**ADDENDUM
NO. 02**

**Franklin Central High School Addition and Renovations Phase 3A.1
6215 S. Franklin Rd
Indianapolis, IN 46259**

ADDENDUM NO. 2 (TWO)

DATE: March 28, 2025
PROJECT: Additions & Renovations to Franklin Central High School
Phase 3A.1
OWNER: Franklin Township Community School Corporation
PROJECT NO.: 2024040.00

2 FIRST FLOOR PIPING PLAN - UNIT H
1/8" = 1'-0"

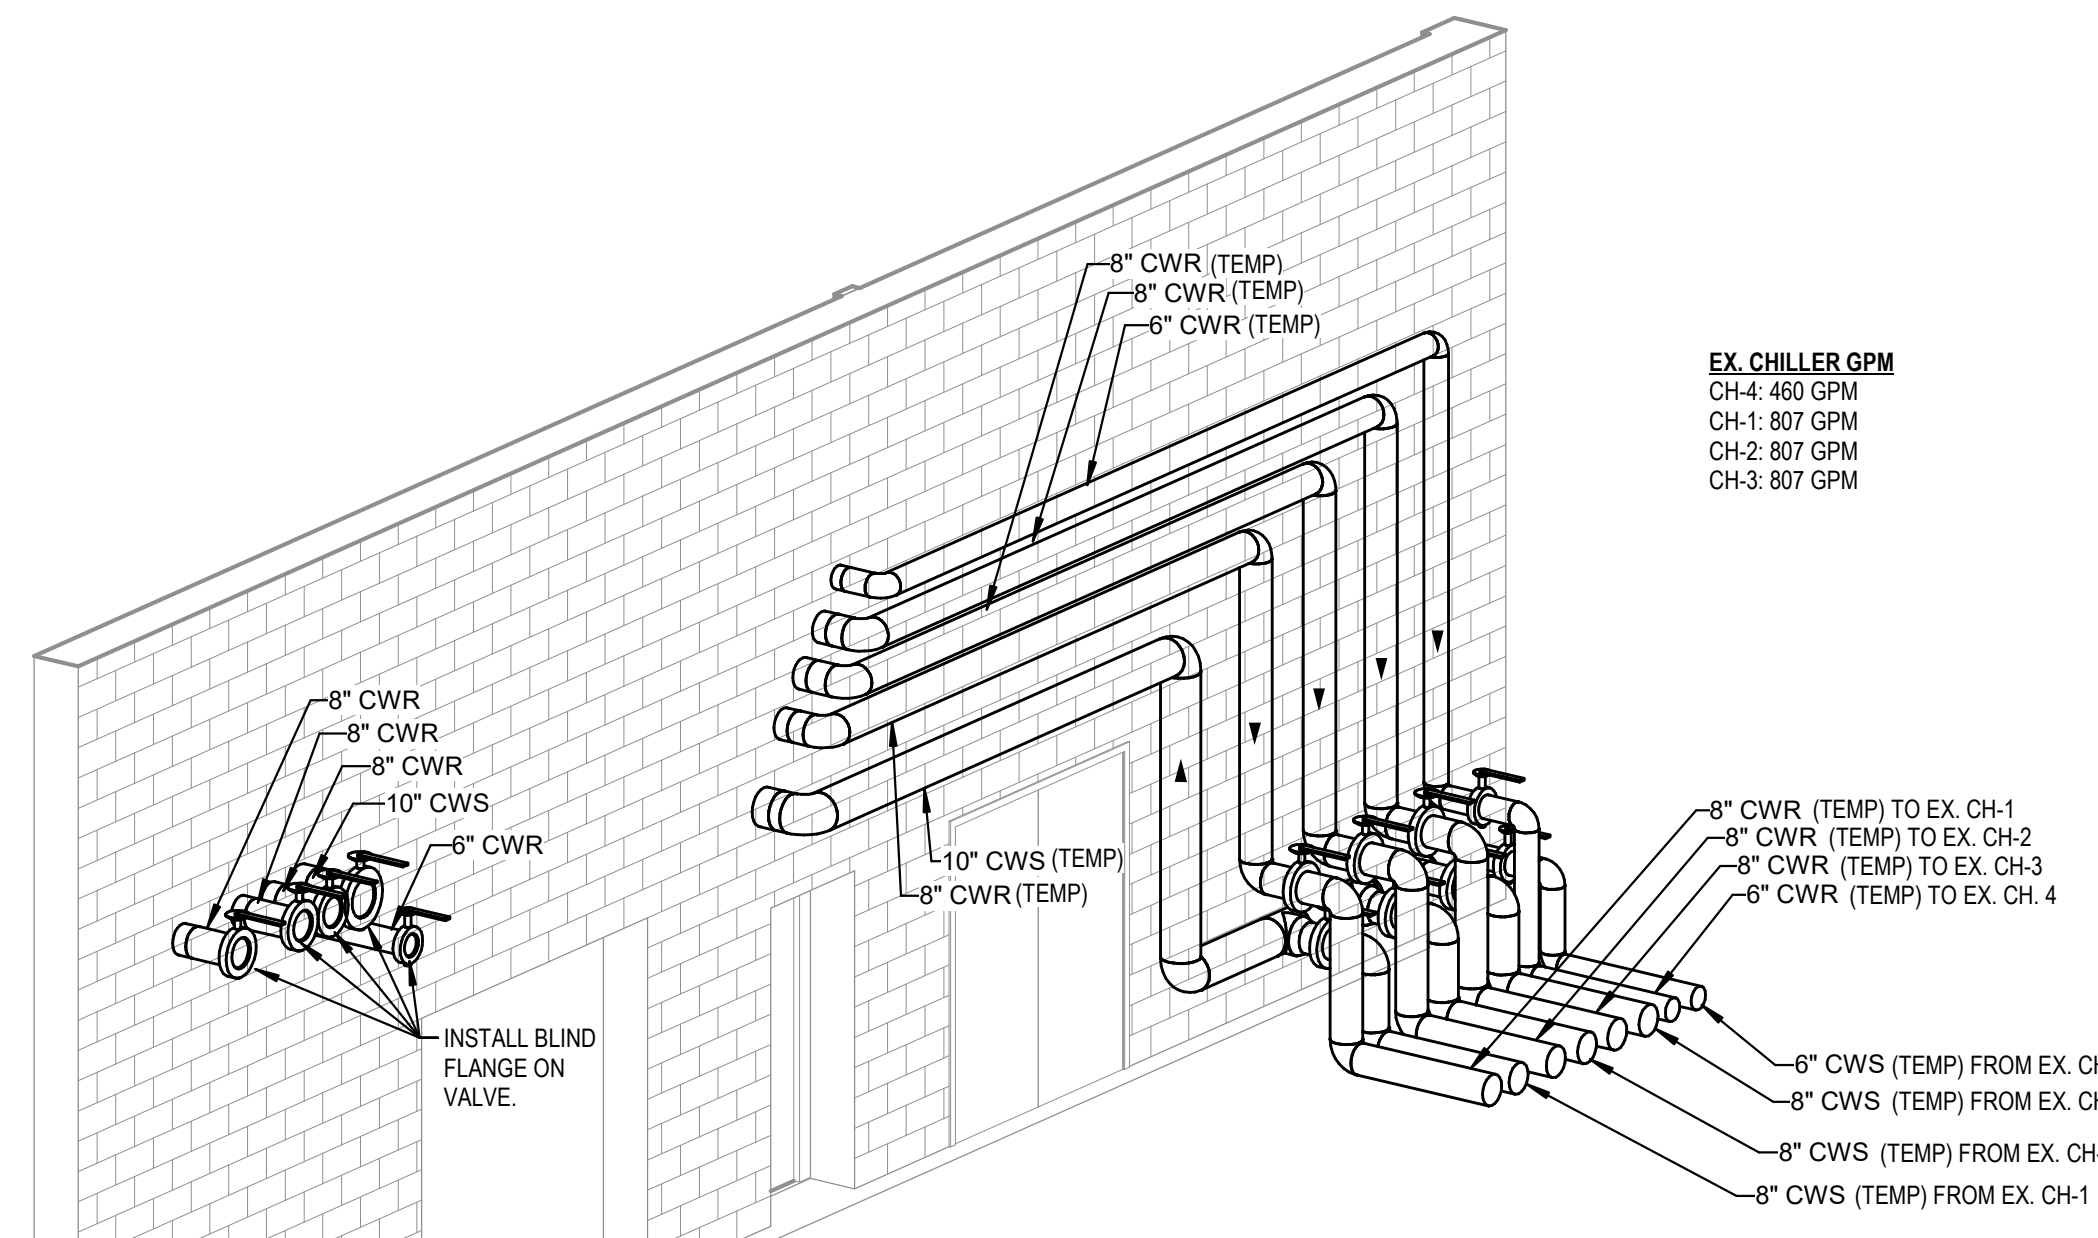
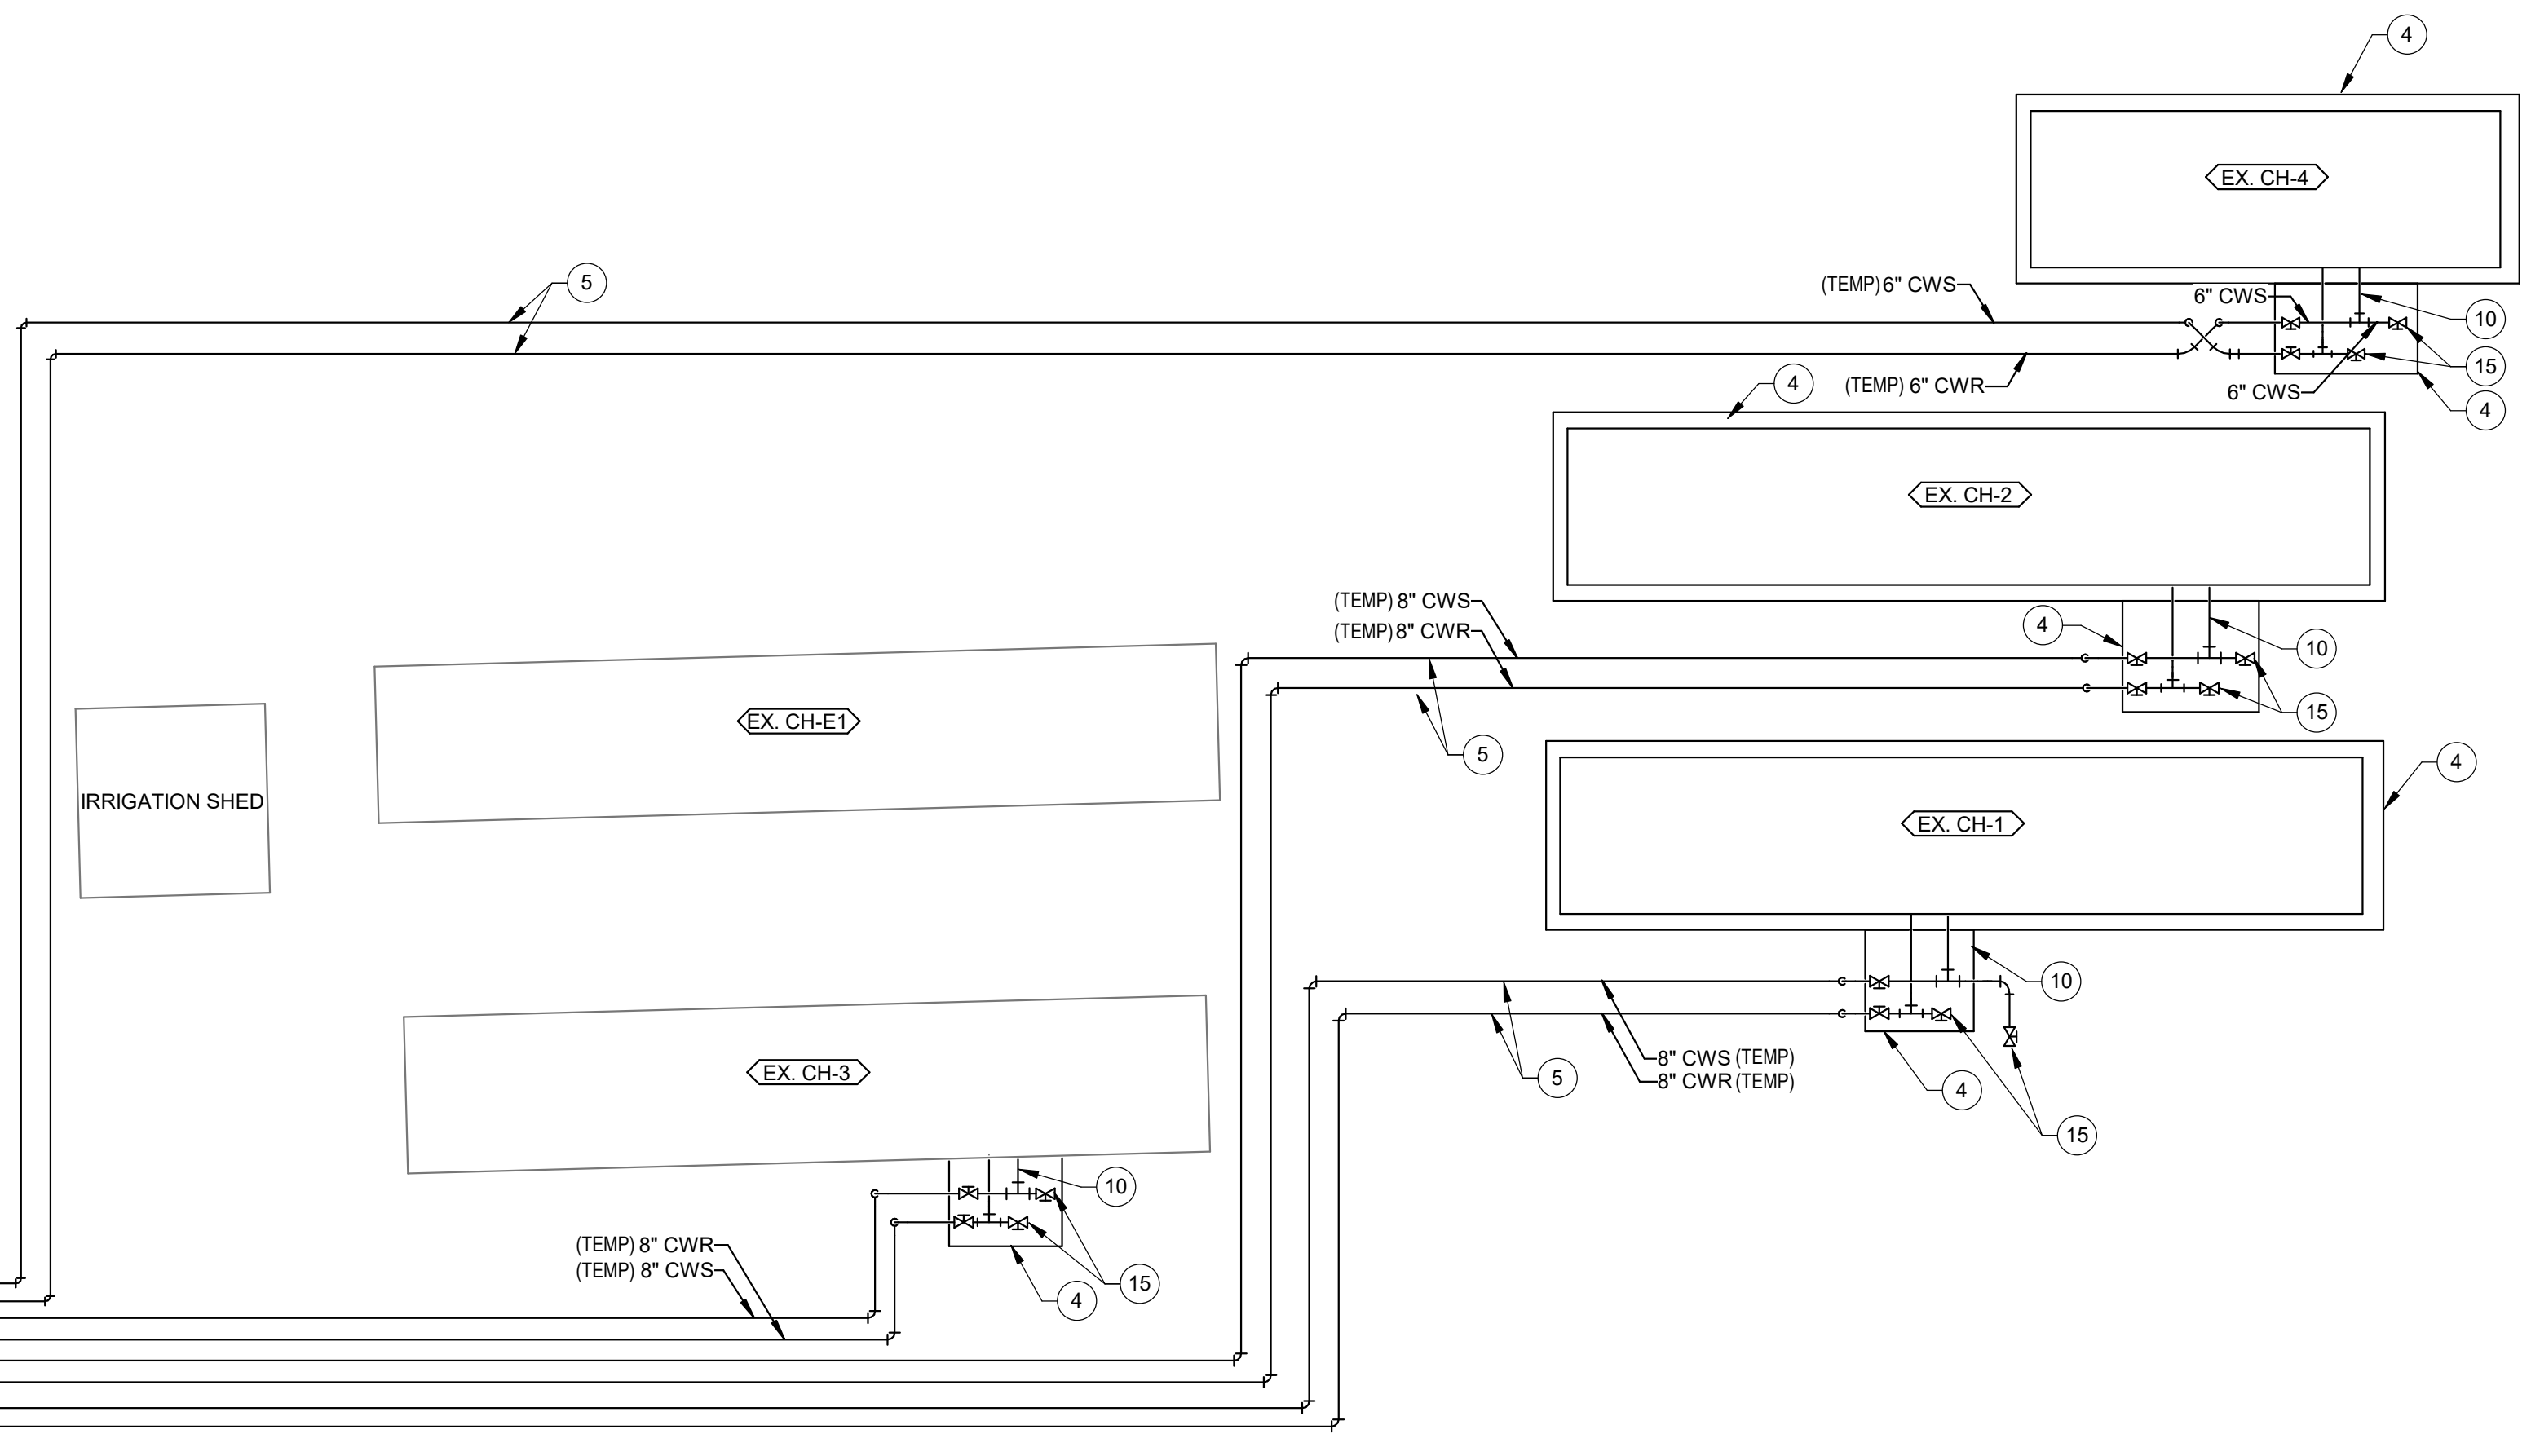
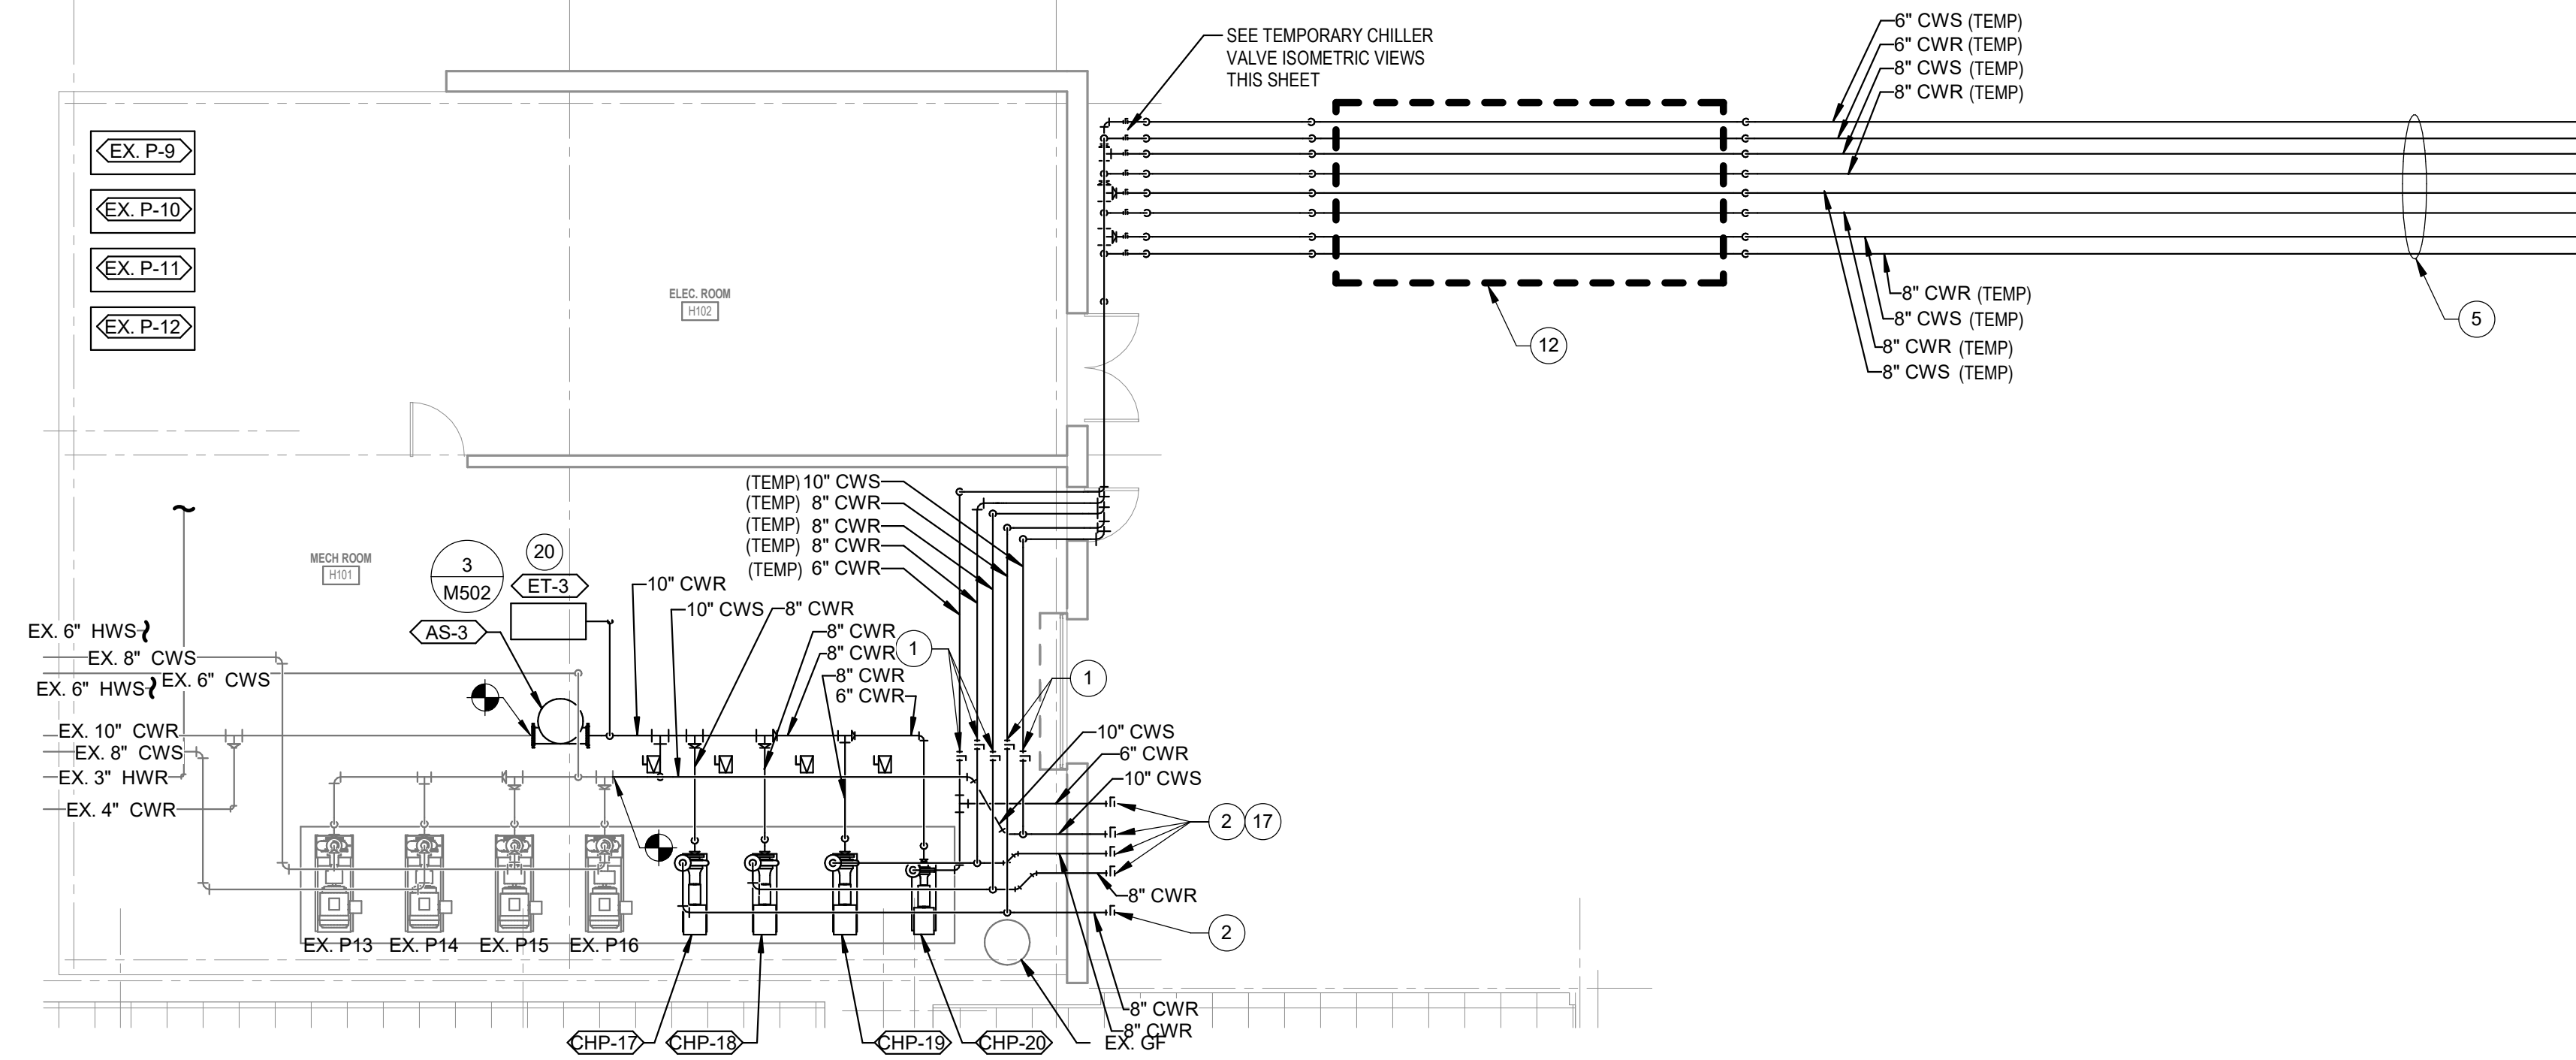
- 2-11 MP1H: Replace drawing in its entirety with attached revision.
- 2-12 MP1V.A: Replace drawing in its entirety with attached revision.
